ADDENDUM NUMBER: THREE (03)

ADDENDUM DATE: January 05, 2017

PROJECT: New Modular Police Building
Ahtahkakoop, Saskatchewan

**SHEET TITLE CRAWLSPACE PLAN
VENTILATION
ROOMS 136 AND 139**

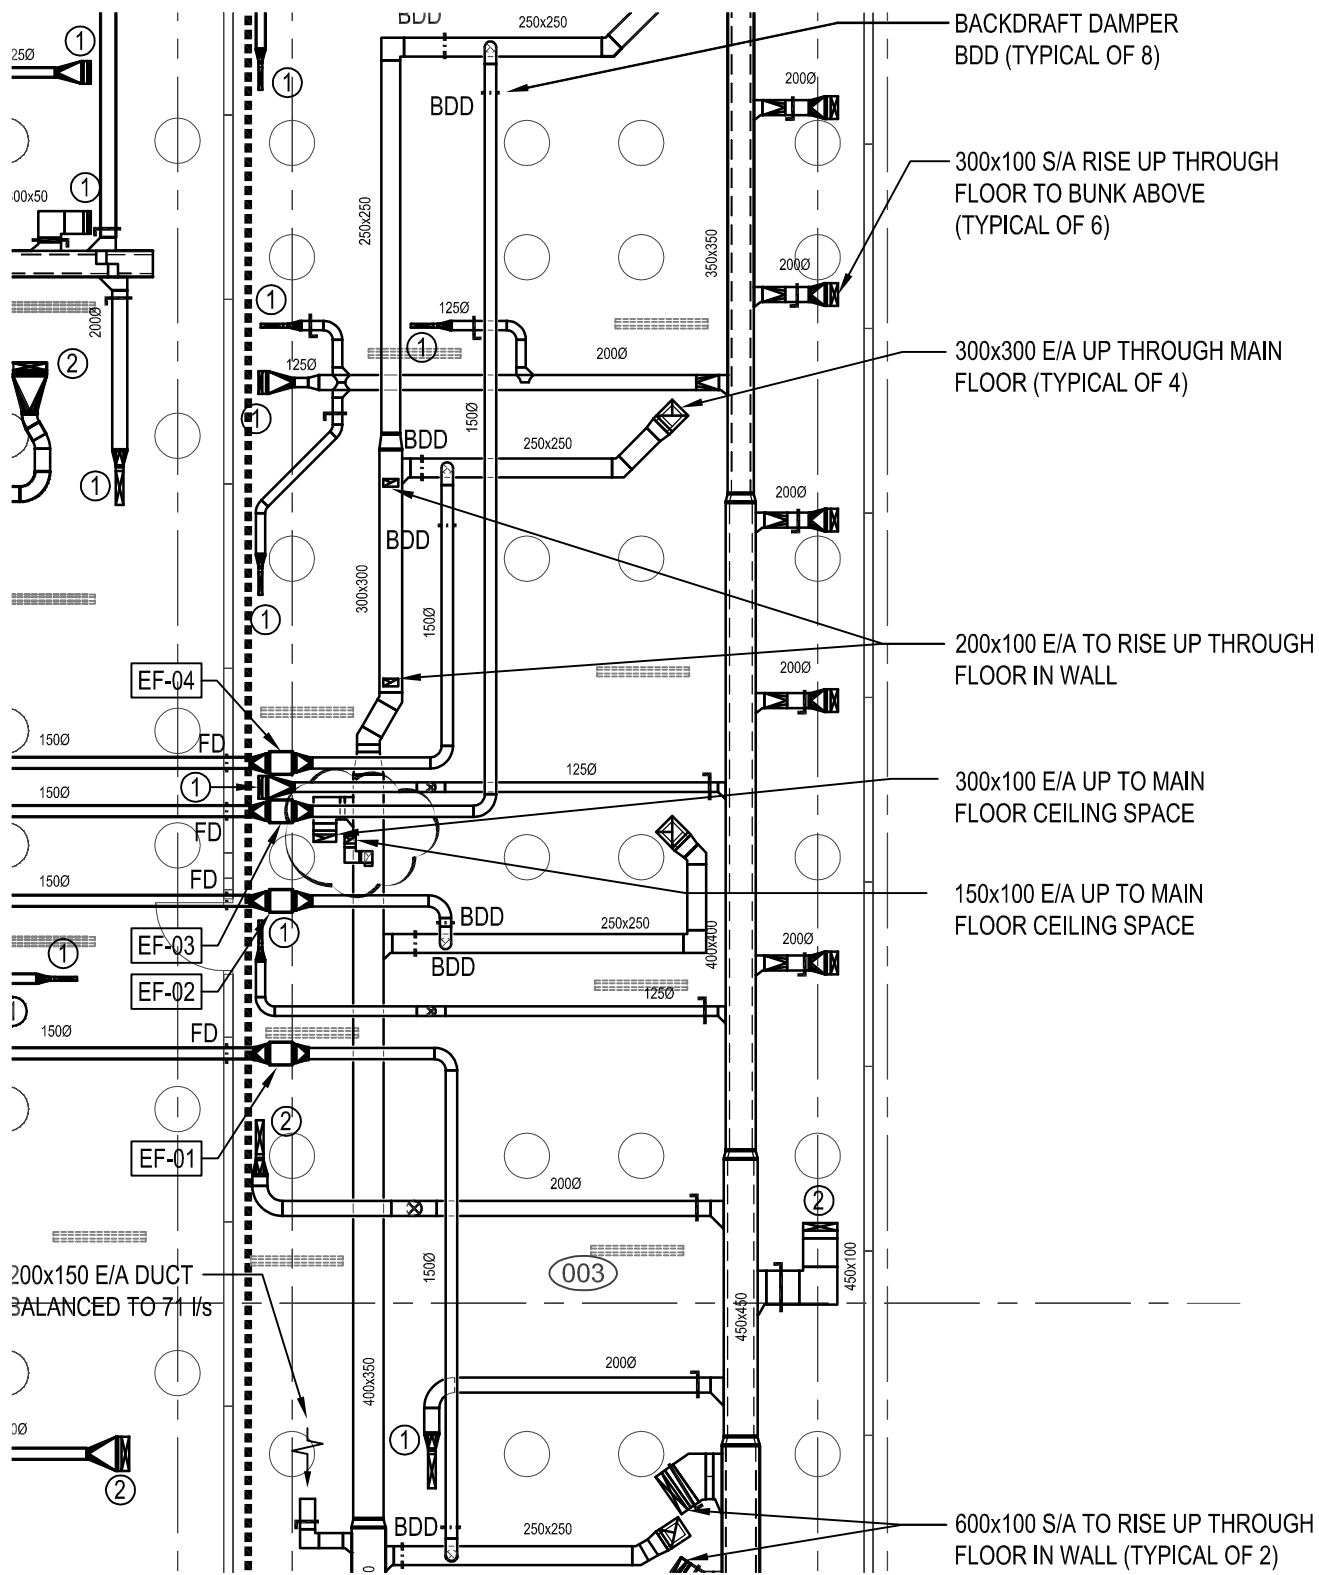
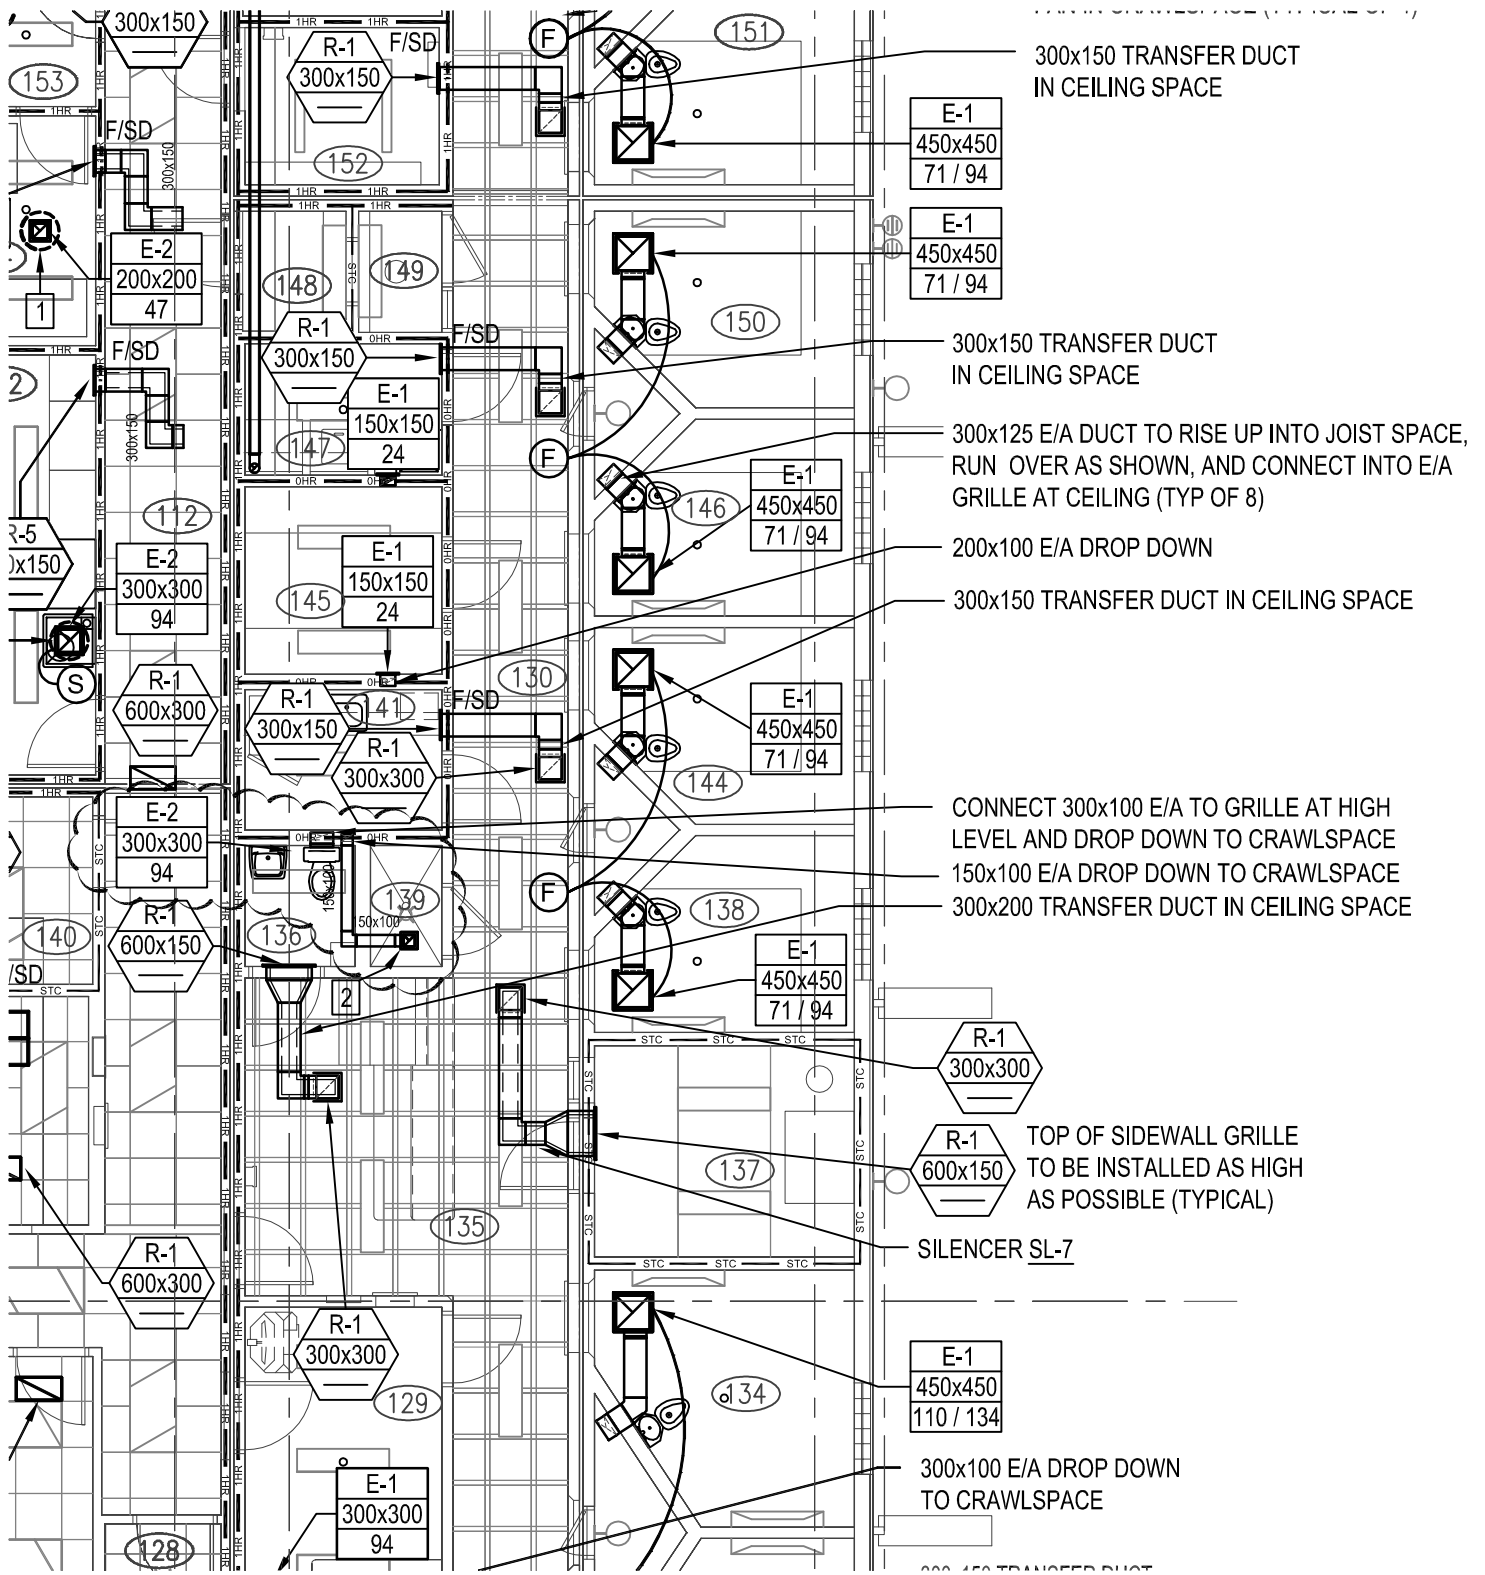
1. Refer to attached sketch M4.1-R01 for modification to duct routing at Room 136 and Room 139.
